SUPPLEMENTAL INSTRUCTION

PROJ.: **Boys and Girls Club Prince of Wales**
PROJ. No.: **1716**
DATE: **June 20, 2018**
S.I. No. **S.I. - 033**

Relocate Sanitary and Storm Connections – **REVISED SANITARY**

S.I. No.: **SI-C-03**
Project: **1463 Prince of Wales Dr.**
Date: **June 19, 2018**
Subject: **Relocate Sanitary & Storm Sewer Connections**

C-02

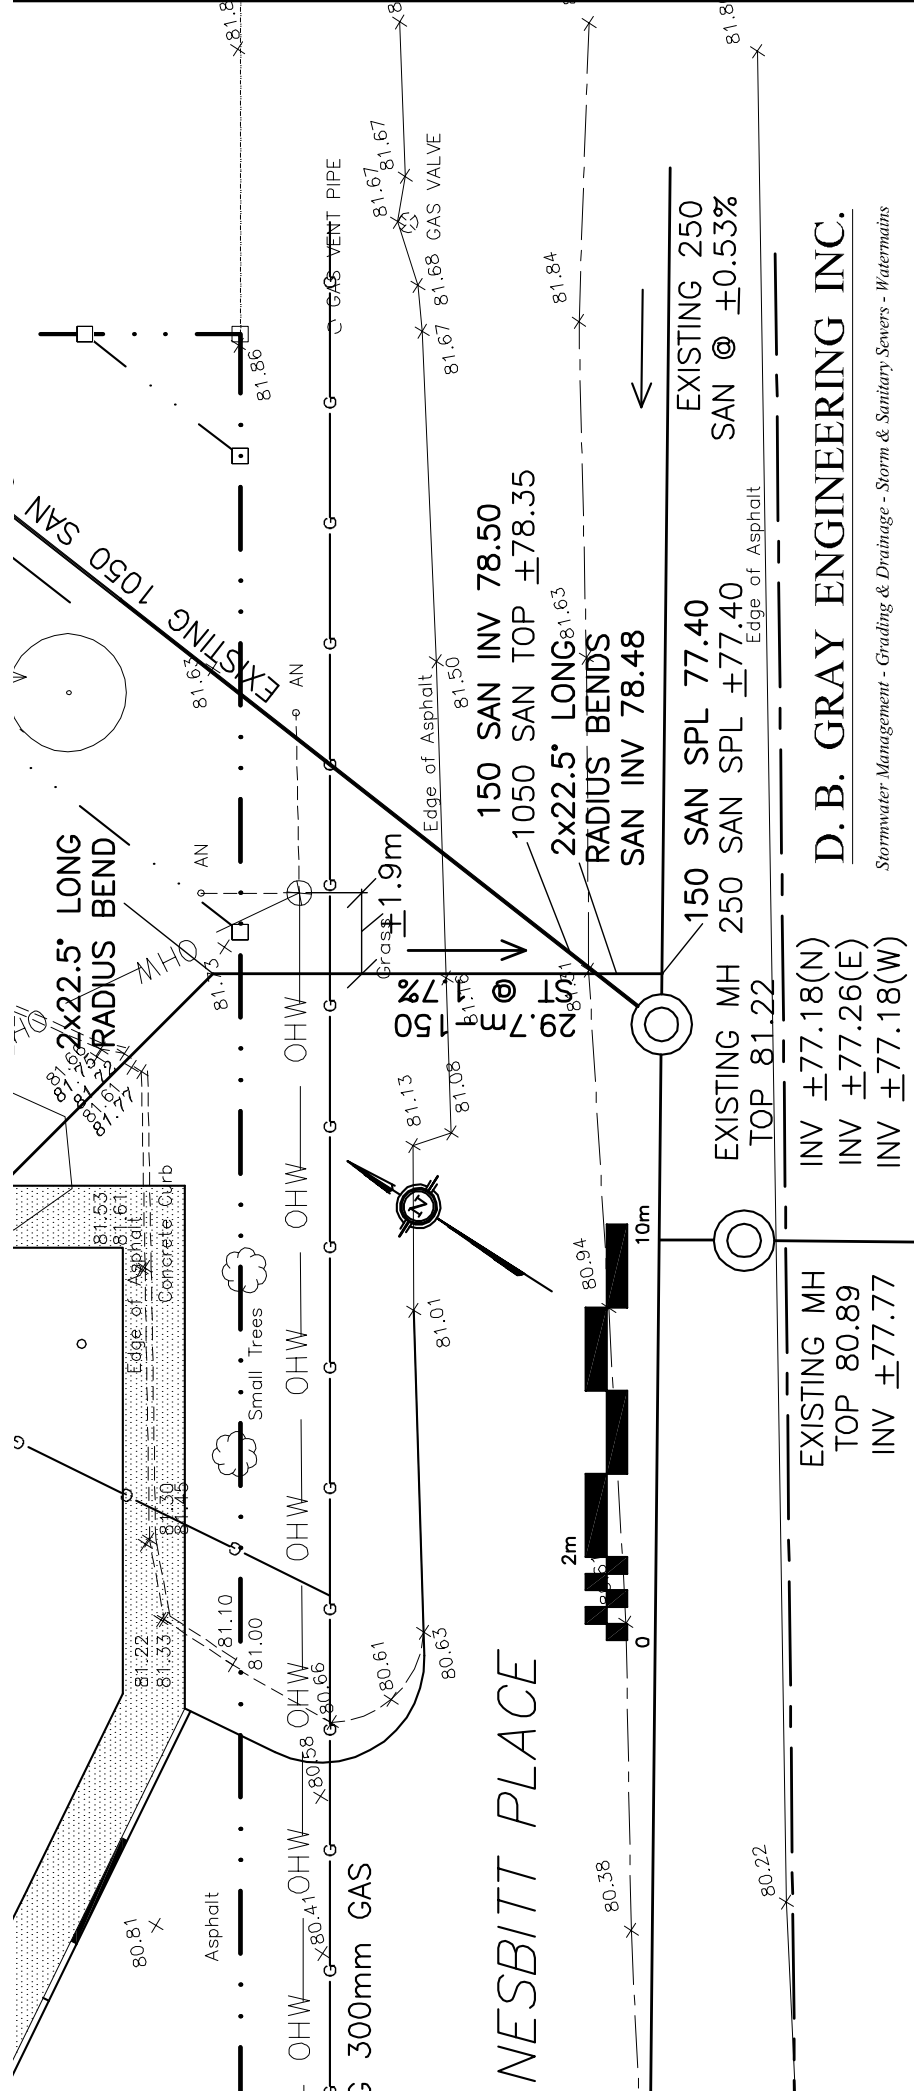
Please note that only the sanitary revisions of SI-C-02 are being superseded by SI-C-03. All other instructions pertaining to the storm sewer are to be revised as per SI-C-02.

Revise the following as per sketch C-02 dated Jun19-18:

-Sanitary sewer connection and length.

150 SAN INV 78.50
 1050 SAN TOP ±78.35
 2x22.5° LONG RADIUS BENDS
 SAN INV 78.48

150 SAN SPL 77.40
 250 SAN SPL ±77.40
 EXISTING 250 SAN @ ±0.53%
